Re-initiation Meeting

TIP Project No. R-5808 WBS 46972.1.1

U.S. Route 158 Improvements From Acorn Hill Road (S.R. 1002) to the Pasquotank County Line Gates County

April 2021

Exhibit 1. Alternative 1 and 2 Adjacent to the Refuge Proposed Typical Section

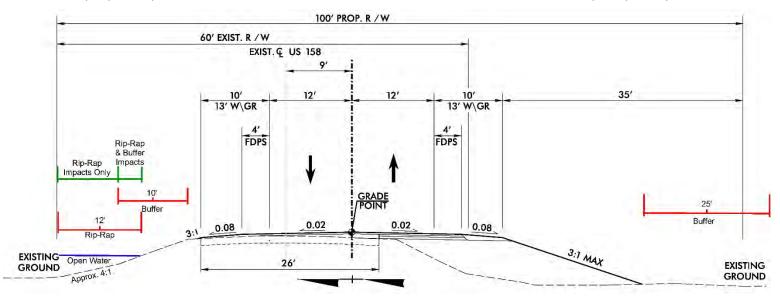
Kyle said that the 4:1 existing slope assumption used by the project team was very conservative as the existing slopes were most likely much steeper. Stephen Holland agreed and said that the slope greatly varies so this was selected as a conservative estimate. If the slopes are steeper, the amount of rip-rap impact estimated would decrease.

Kyle raised concern regarding the statement that there would be additional risk of settlement and slope degradation when widening to the north since the rip-rap was proposed to be placed there for protection. Colin and Stephen explained that the settlement concerns are associated with the total weight of the fill, rock plating/rock embankment, and roadway pavement being placed on the unsuitable soft sub-grade. The rip-rap would only protect the surface of the slope from additional degradation.
